12/8/03 York Substation Community Meeting Summary #1

Meeting purpose: to inform the community about development possibilities and come to a community consensus on desired park programs and character.

Concept A

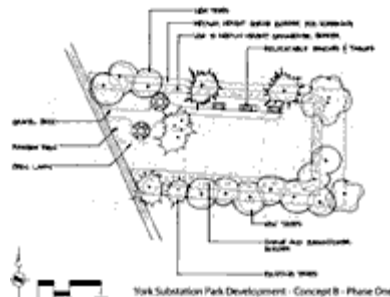
The community members present at the 12/8/03 meeting were not enthusiastic about play equipment in the park, and preferred Concept A of the three alternatives. Community members suggested new ideas for Parks to consider including growing vines on boundary fences, an historic marker of Renton highway, sculpture that is evocative but subtly blends into the landscape, play sculpture that is imaginative, trees that offer flowers and fall color. Some questions asked at the meeting:

Concept B1

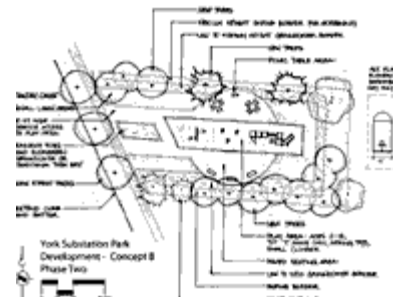
- Concept A would cost under \$150,000, and some community fundraising would be required.
- Concept B2, with play equipment and parking strip development, would cost approximately \$250,000 to develop.
- The cost of Concept B1 is within the \$109,000 Pro Parks appropriation and would not require any community fundraising,
